AKOURI CONSULTING ENGINEERS

RE Summary of repairs and recommendations obtained from the Milestone Phase 1 and 2 for the building located at:

Las Vistas in Inverrary Condominium Association Inc.
3541 Inverrary Dr Bldg G, Lauderdale, FL 33319

Unit 206

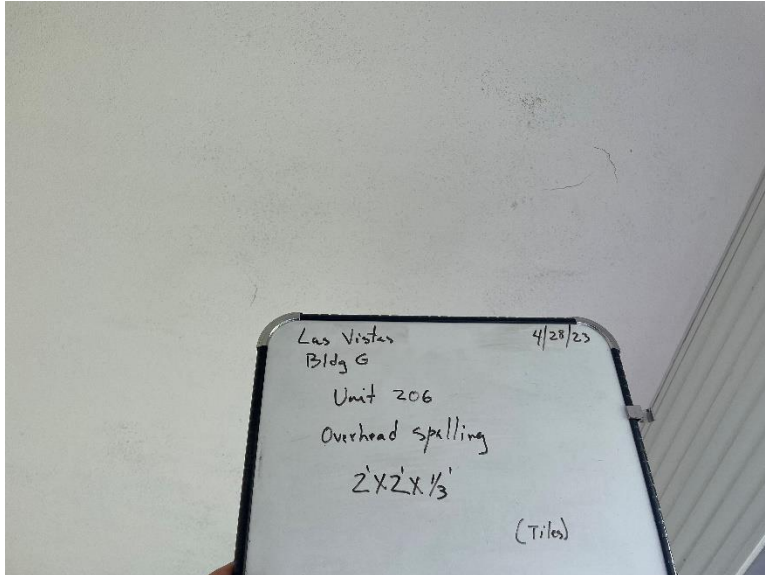
The listed deficiencies below must be corrected in accordance with a concrete restoration bid package prepared by a structural engineer and approved by the Local Building Department.
